## STAFF COMMENTS FOR PLANNING COMMISSION

**SITE PLAN:** **SDP-7059-2015**

**TITLE:** **MEDIMMUNE GARAGE "C"**

**SUBJECT:** Staff Analysis: SDP-7059-2015  
Medimmune Garage "C"

West Façade – Phase 1

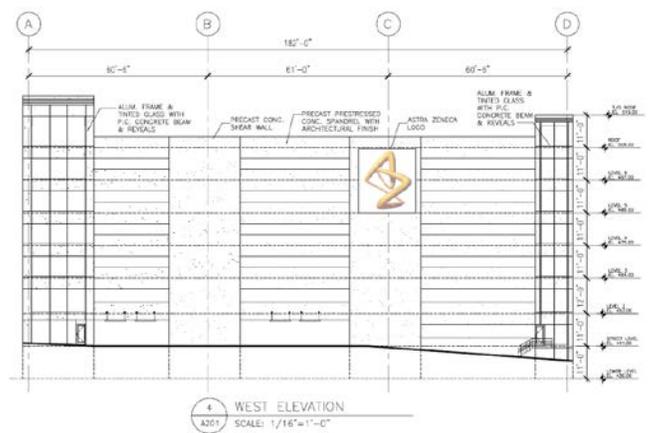
Phase 1 interim façades for the west and north elevations are presented along with the final elevations below. Due to its visibility from Quince Orchard Road, staff recommends that some additional features be added to the west façade.

- 4) Applicant shall work with staff to enhance the west garage elevation facing Quince Orchard Road (MD 124) prior to final site plan approval;
- 5) Applicant to submit a revised Preliminary Subdivision Plan (Sheet PP-1.00) prior to the close of the Mayor and City Council record;

**CIVIL PRELIMINARY SUBDIVISION PLAN**

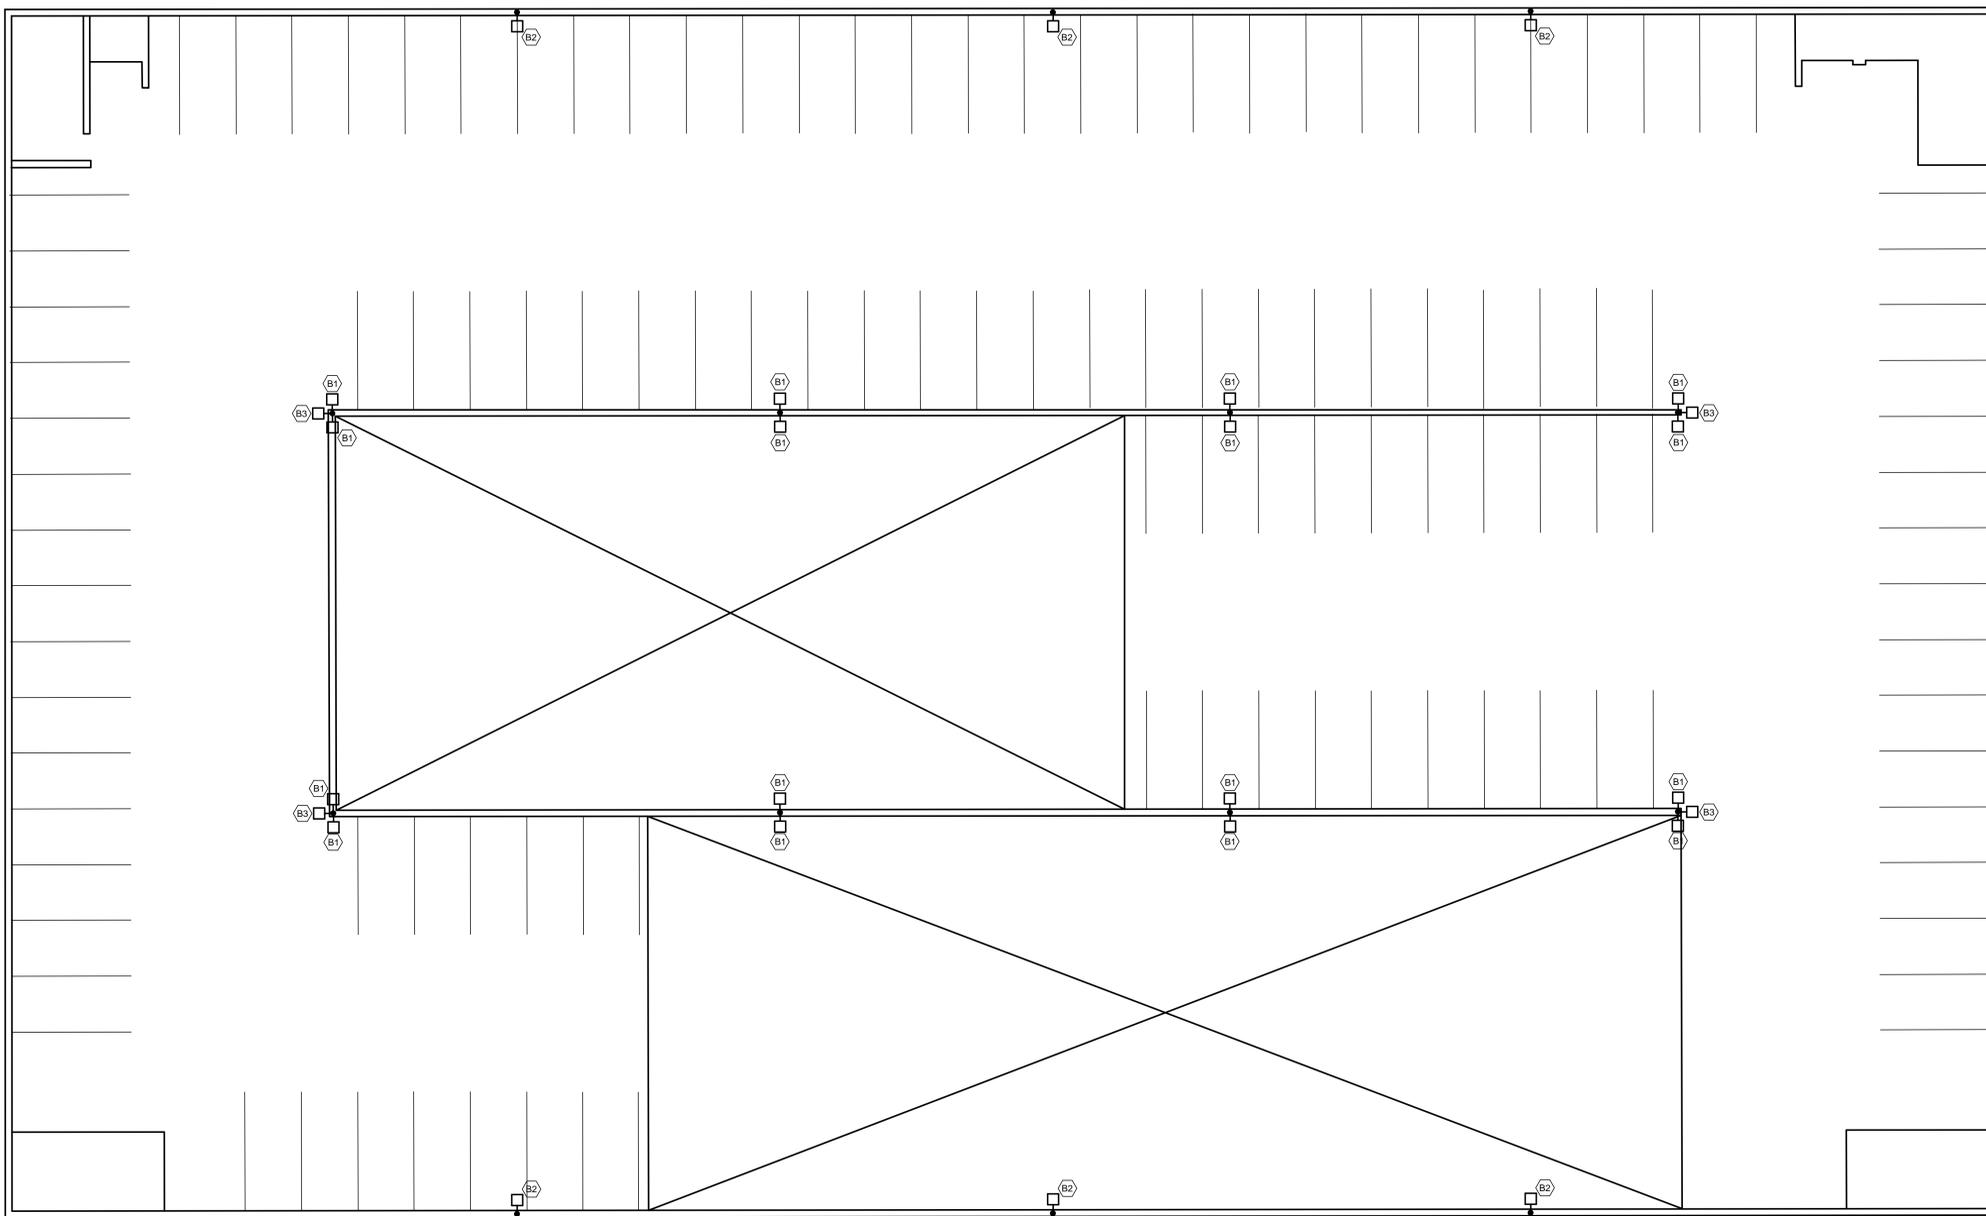
As part of a new Preliminary Subdivision Plan, a new parcel, Parcel B, will be established delineating a 50' right-of-way along Quince Orchard Road for the future Corridor Cities Transitway ("CCT") alignment. Medimmune will dedicate Parcel B upon agreement with the City and/or Maryland Transit Administration as to the timing of dedication, compensation for the dedication, and a possible land exchange arrangement involving the prior Corridor Cities Transitway ("CCT") alignment, provided the Maryland Transit Administration confirms that the prior CCT alignment no longer is necessary for the CCT project (see Exhibits #56-#58).
